## **PRIVATE PLAN CHANGE 98**

### **HEARING REPORT**

## **50 PUKEKOHE EAST ROAD AND 47 GOLDING ROAD**

## Hearing Report for Proposed Private Plan Change 98: Pukekohe East-Central Precinct 2 to the Auckland Unitary Plan (Operative in part)

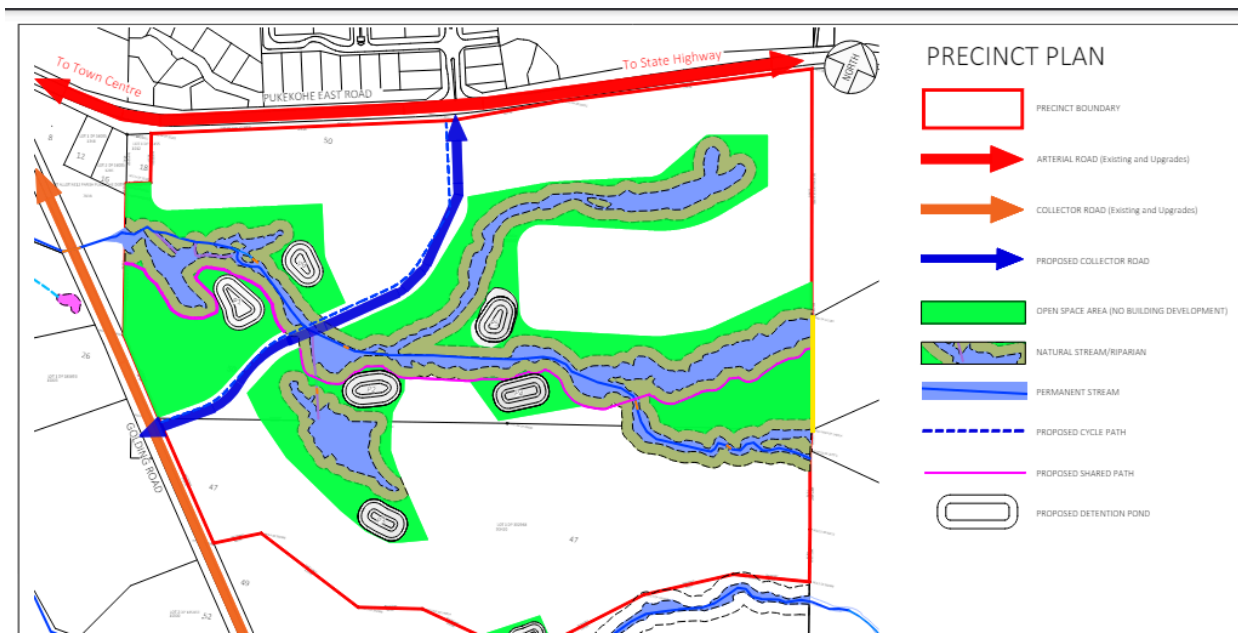
We are the property that borders the precinct boundary on the north eastern edge where there is a proposed open space with a shared pathway leading up to our fence line. We currently have free range poultry and stock running in these paddocks with post and batten 7 wire rural fencing and enjoy good rural views to the west.

On the Concept Master Plan PC2 an open spaced area proposed shared pathway and proposed riparian planting and stream would extend up to our western boundary. We have concerns that when development occurs, members of the public will have ease of access right up to our rural boundary fencing. This will impact on our privacy, amenity values, security and enjoyment of our rural lifestyle block. As we have both free range chickens and stock on our property, we are also concerned that people and dogs using the open space areas and proposed shared pathway would have an adverse affect on them.

Figure 2: Open Space Gap Analysis (The blue circles demonstrate the need for neighbourhood parks)

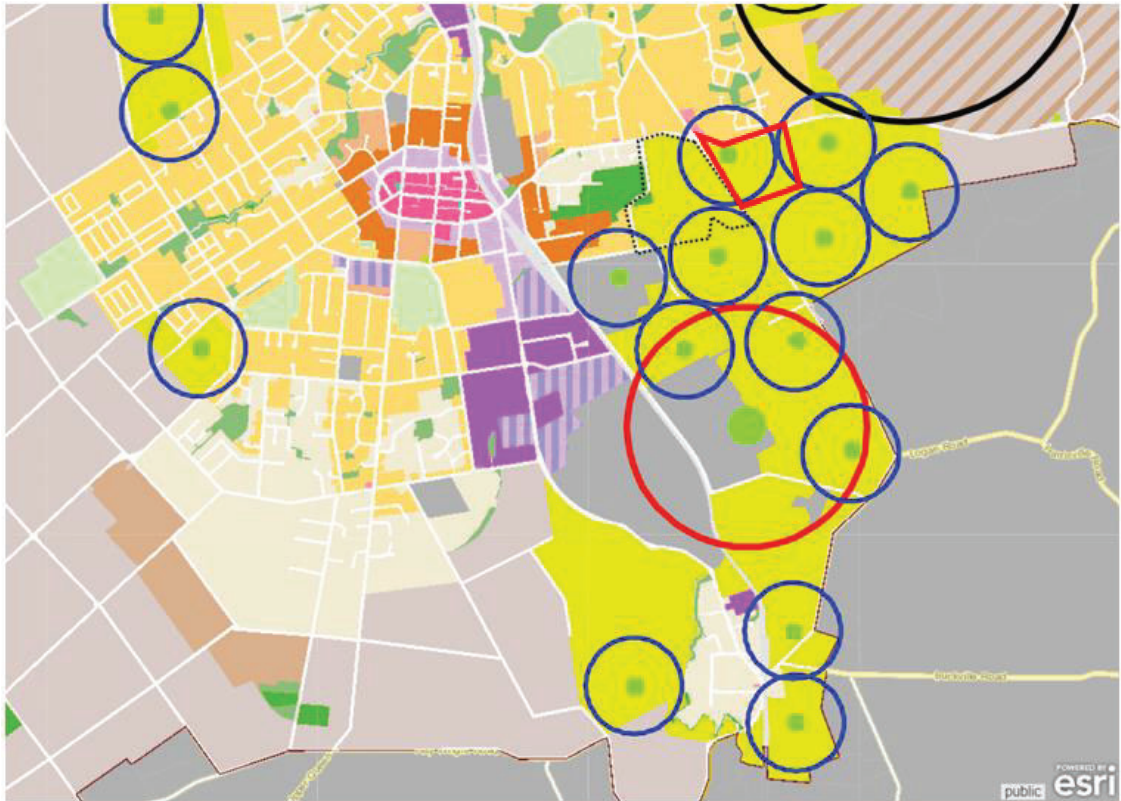
5.18.4. Figure 1 below shows the revised open space locations across the Pukekohe-Paerata Structure Plan area, superseding the indicative locations shown in the structure plan.

5.18.5. Therefore, there is a gap within the open space network regarding formal recreation in the location of the PPC area, and a new neighbourhood park is required within the precinct area.

Figure 3 North and South proposed neighbourhood park locations.

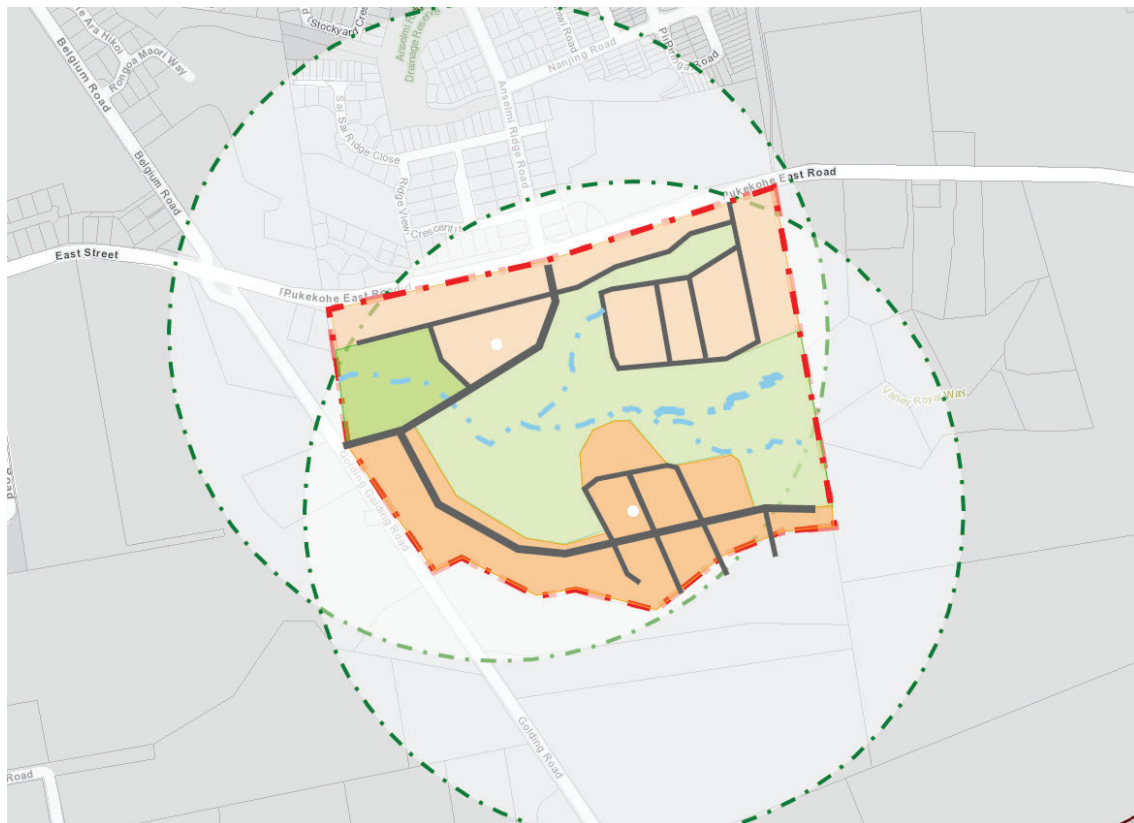
5.18.8. From an open space provision perspective, the open space provision specialist considered two options for providing a neighbourhood park in Figure 2 below. The northern site potentially interfaces with a newly proposed collector road but is in a legible area of the site and is directly related to other open spaces. It can be envisaged that the proposed superblock will face further subdivision, resulting in additional local road connections, which will soften the interface as opposed to the collector road. Through discussions with the applicant, we found that the site is constrained by gradient issues.

5.18.10. Neither site location will result in a provision gap for the proposed plan change area. The southern portion may yield a more efficient, wider network as it can support growth areas south of the proposed plan change area. Due to local roads, the southern location is preferred. However, either location must have pedestrian bridges to ensure that the park is easily accessible and well-integrated with the surrounding area.

Section 42A mark-up amendments to the PC98 Precinct Plan (marked in orange)

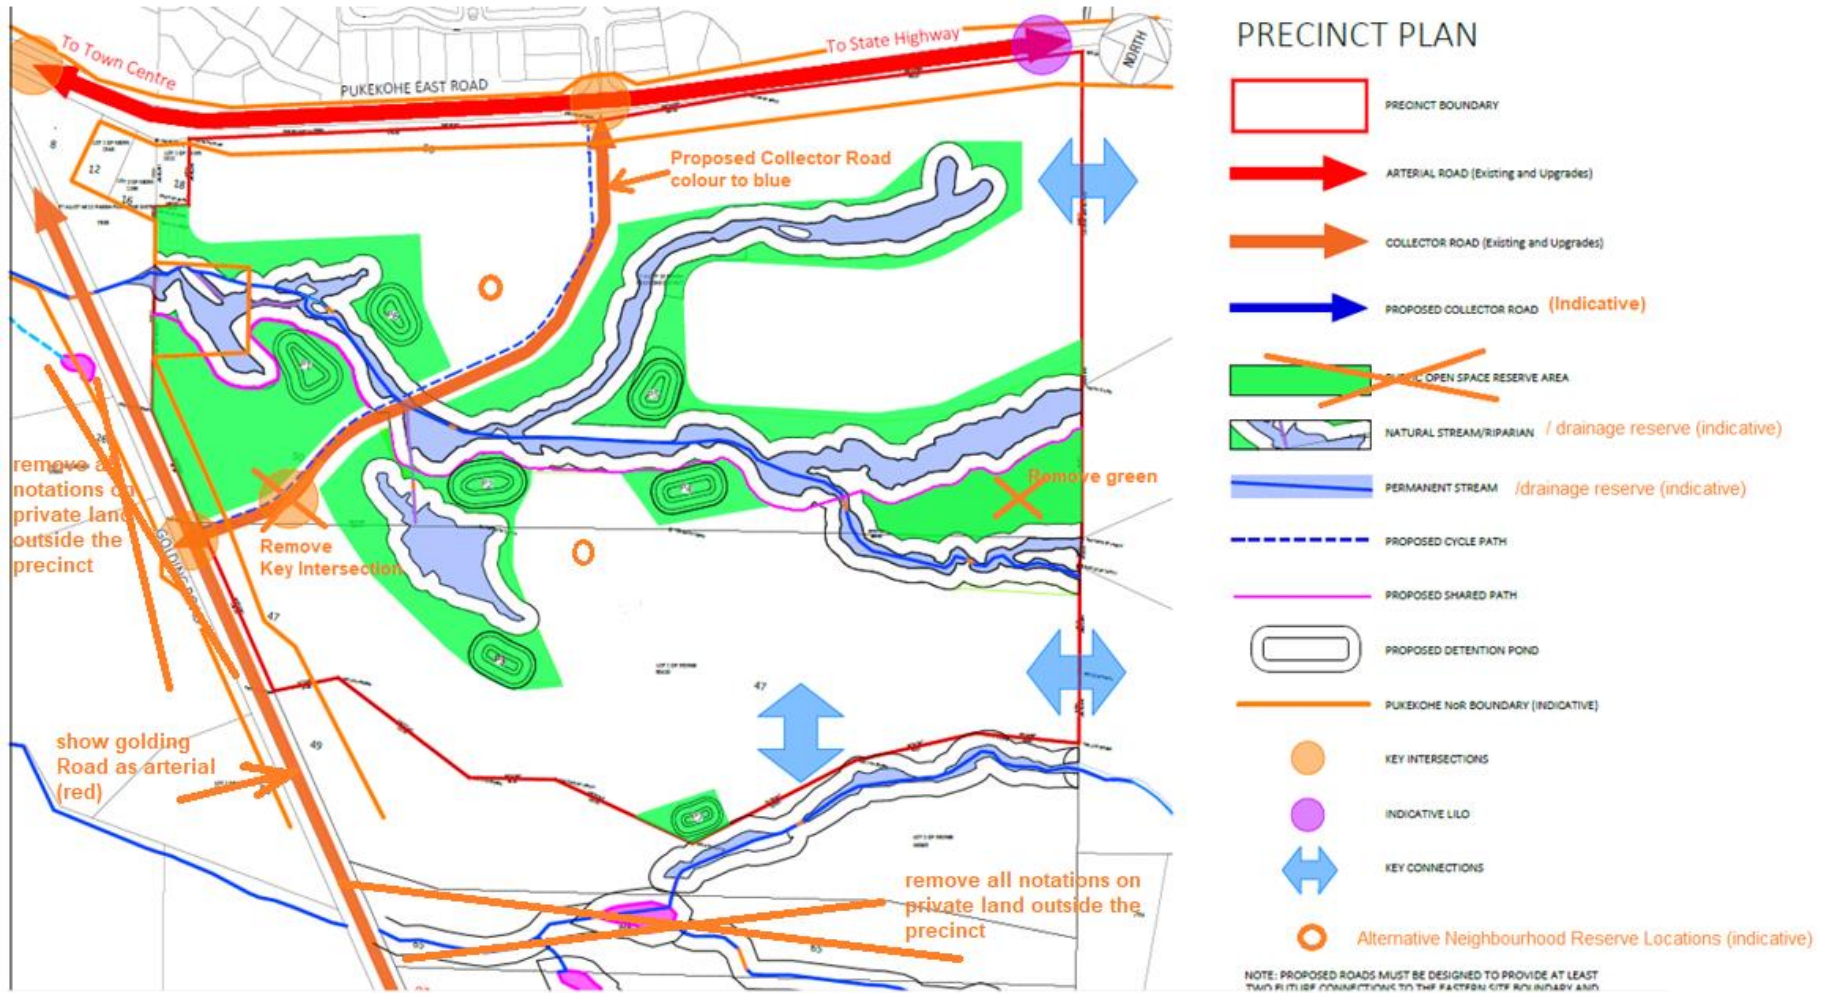
**I45X.9 PUKEKOHE EAST-CENTRAL: PRECINCT PLAN 1 (NB Auckland Transport submission to amend Precinct Plan)**

Note 6: The Collector Road shall be designed to discourage through traffic, particularly freight and heavy vehicles.

**Commented [PR53]:** See specialist transport review
